Fashion Flash Ltd

149, Shah Kabir Mazar Road, Dakkin Khan, Azampur, Uttara, Dhaka
(23.86819N, 90.41251E)

5th April 2014

Observations

Construction Joint

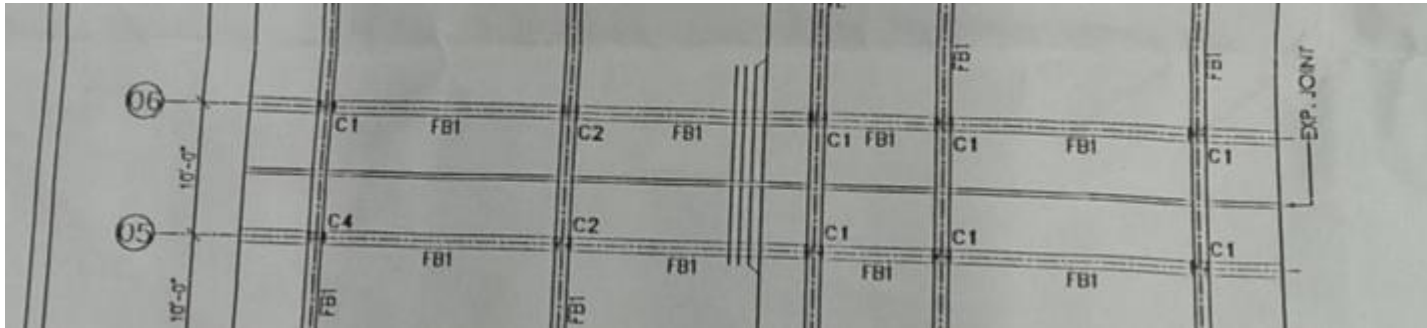
Construction joint generally covered and cannot be inspected. Structural drawings show beams are continuous through joint. Engineer to confirm that beams and slab are designed and detailed separate as cantilevers

Ensure joint is sealed at roof level to prevent water ingress

Unrestrained roof parapet

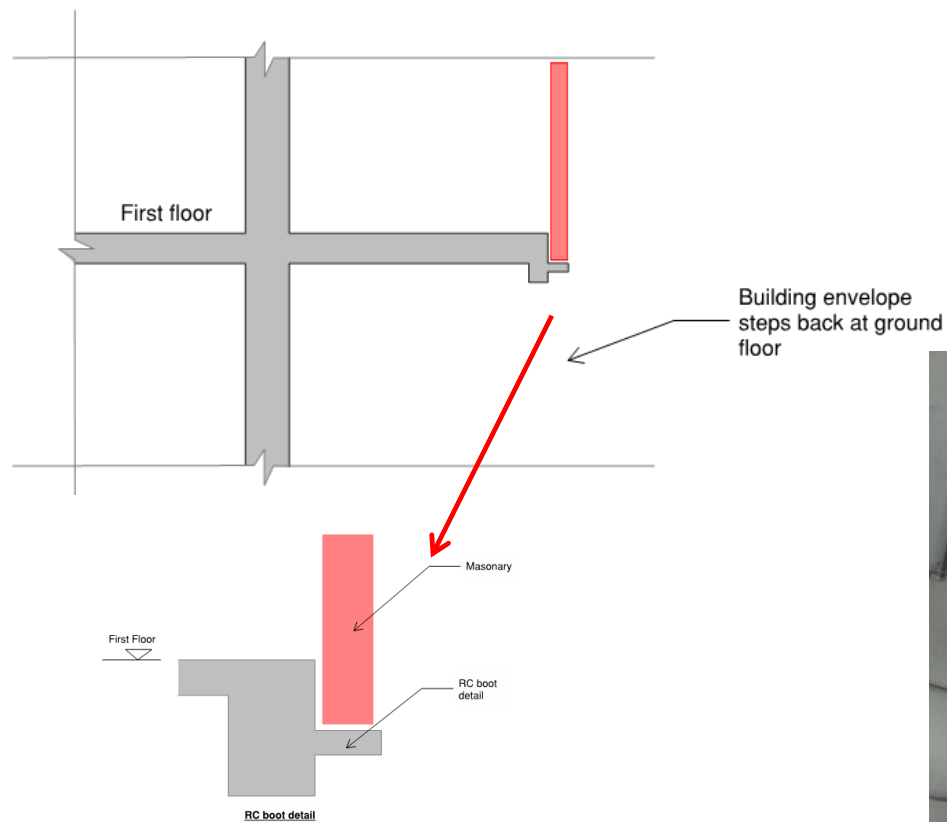
**Single leaf masonry parapet wall
unrestrained at roof level.**

Design check required to confirm lateral
stability under wind load.
